Kimberly Fashions Ltd.

15th January 2018

Observations

Observation : Factory Shed

Discrepancies between drawings and on site condition

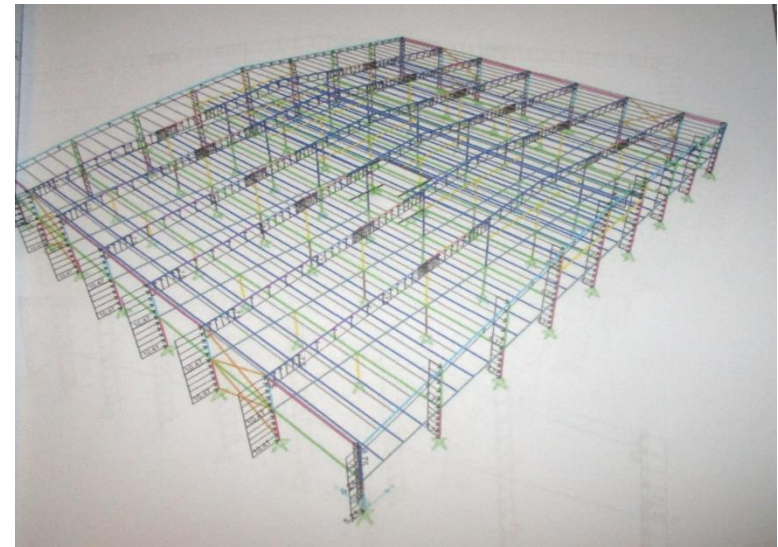
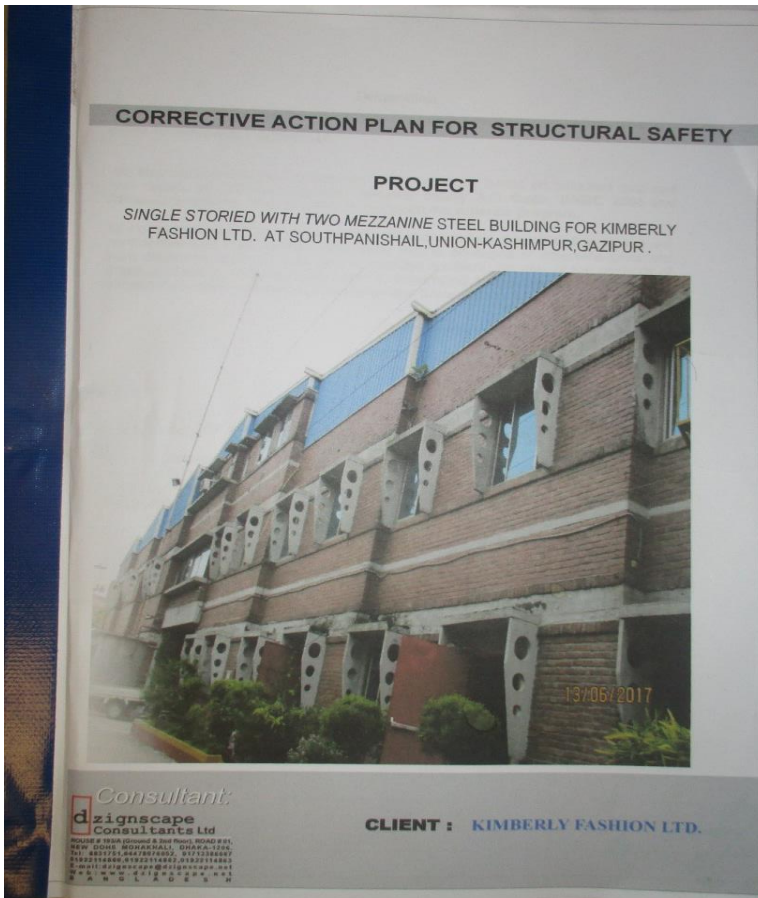
In as built drawings rafter R-04 is mentioned as W:275x4 mm; F:150x5 mm but existing rafter size were found W: 195 mm; F: 120 x 5 mm.

Smaller sectioned columns have been welded with steel columns for extension. But the joint details was not available in provided drawings.

Item No.	Observation	Recommended Action Plan	Recommended Timeline
1	Discrepancies between drawings and on site condition	Building Engineer to survey as-built structure and prepare accurate as-built survey information with connection details for the building.	6-weeks
2	Incomplete assessment report	Factory is required to submit complete assessment report including software based analysis file to Accord for further review.	6-weeks
3	Incomplete assessment report	Implement remedial works as outcome of design report if required.	6-months
4	Corrosion in steel members	Apply suitable method to protect the steel members.	6-weeks
5	Bolt missing from several joints	Install missing bolts where required.	6-weeks
